RECOMENDED SERVICE BULLETIN

NO. RSB 40-052

Seal between the firewall shield and the fuselage.

“INSTALLATION OF FIREWALL EDGE GUARDS”

DA4-5310-10-00

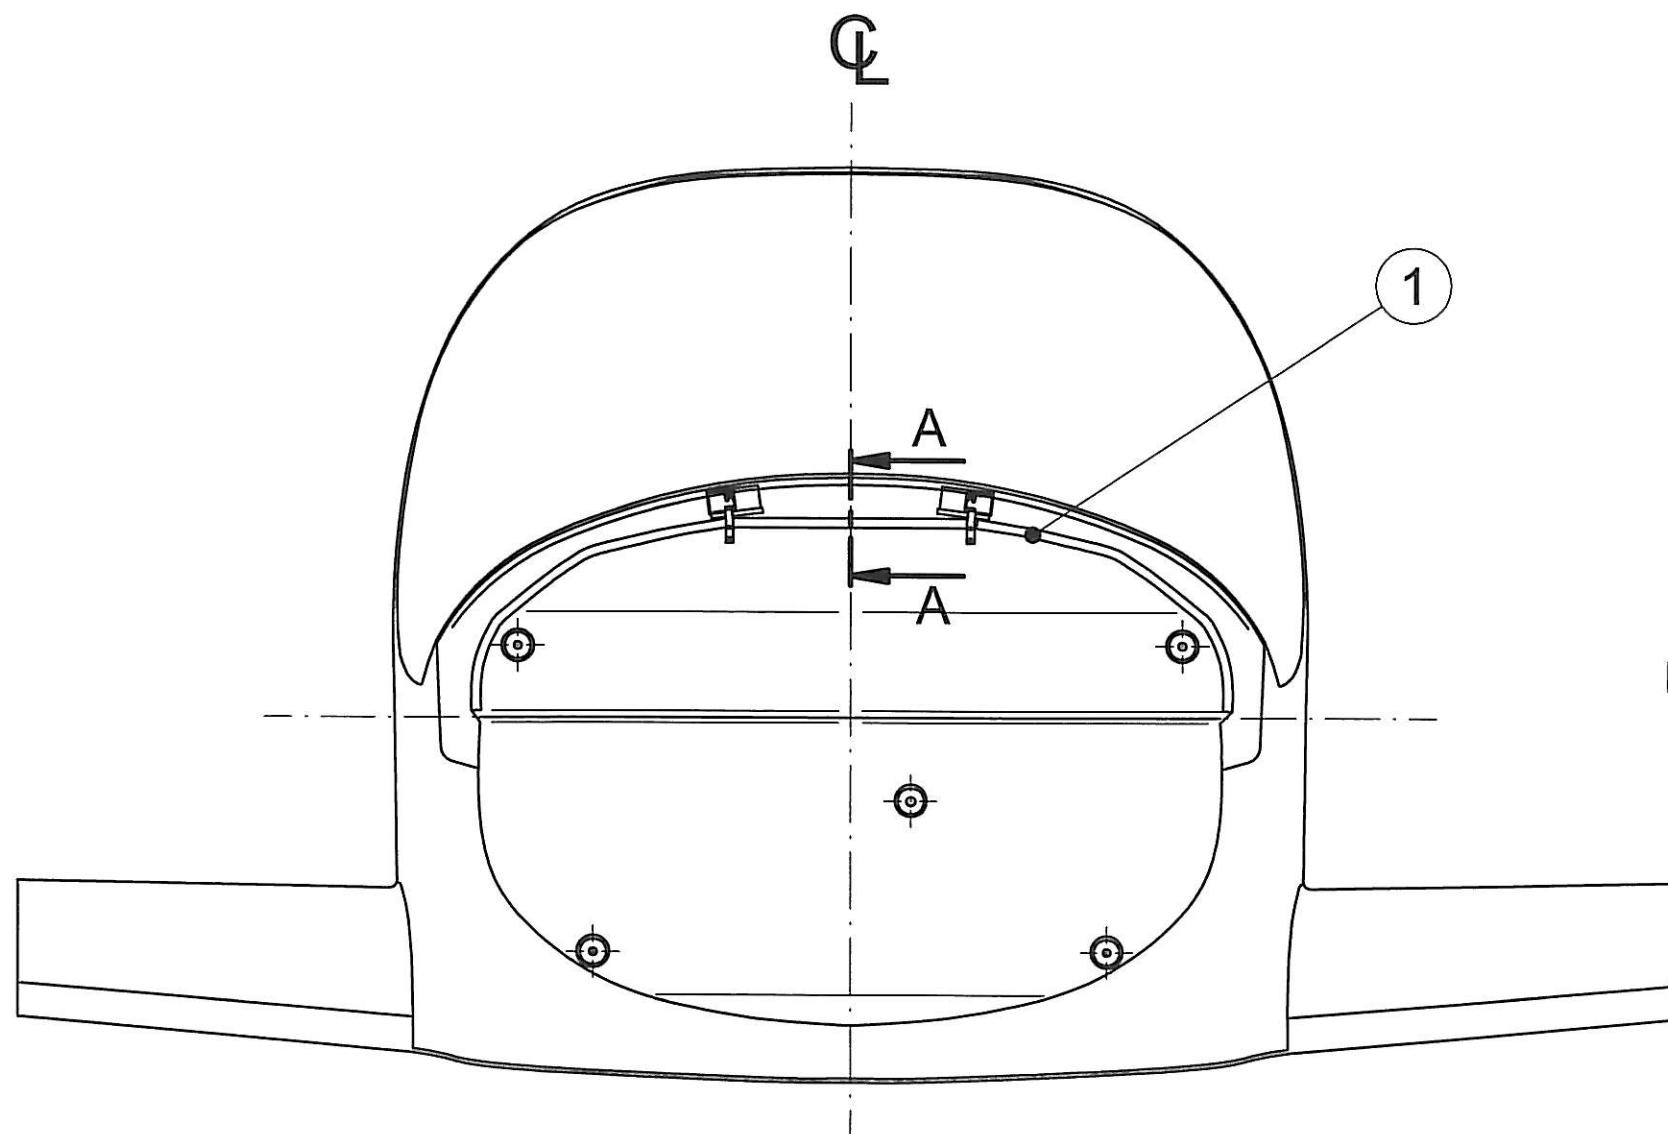
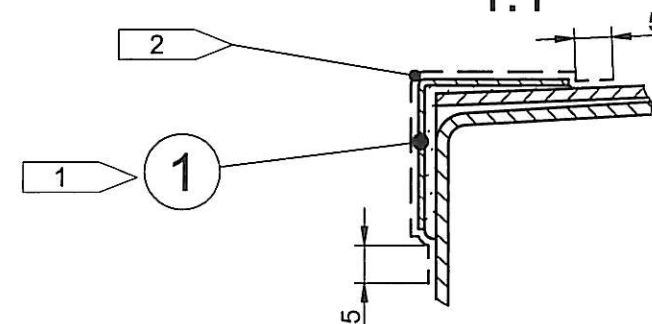
A new seal cover has been approved, which improves the seal of the bond between the firewall shield and the fuselage. The formation of white dust at the bottom edge of the firewall due to moisture in the firewall is prevented.

1	Remove upper and lower cowlings acc. to AMM Section 71.
2	Check that the new seal cover fits proper to the fuselage as shown on drawing DA4-5310-10-00.
3	If it is necessary to trim the seal cover to fit tight to the fuselage, cut small slots into the flange of the seal cover.
4	<p>Mark the outline of the seal cover with masking tape.</p>

11	Coat sealant joint and seal cover with fire resistant paint, in acc. with drawing DA4-5310-10-00 and AMM Section 51-30. NOTE: Apply fire protective paint with 5 mm (0.2 in) excess.
12	Clean working area and check for foreign objects.
13	Install upper and lower cowlings acc. to AMM Section 71.
14	Test all systems in working area for function.
15	Make necessary entries into aircraft logs.

- 1 PASTE UP WITH TEROSTAT 1K-PUR - FA. TEROSON
- 2 PROTECT SURFACE WITH FIRE PROTECTION PAINT
ACCORDING TO DPS 14 CHAPTER 1
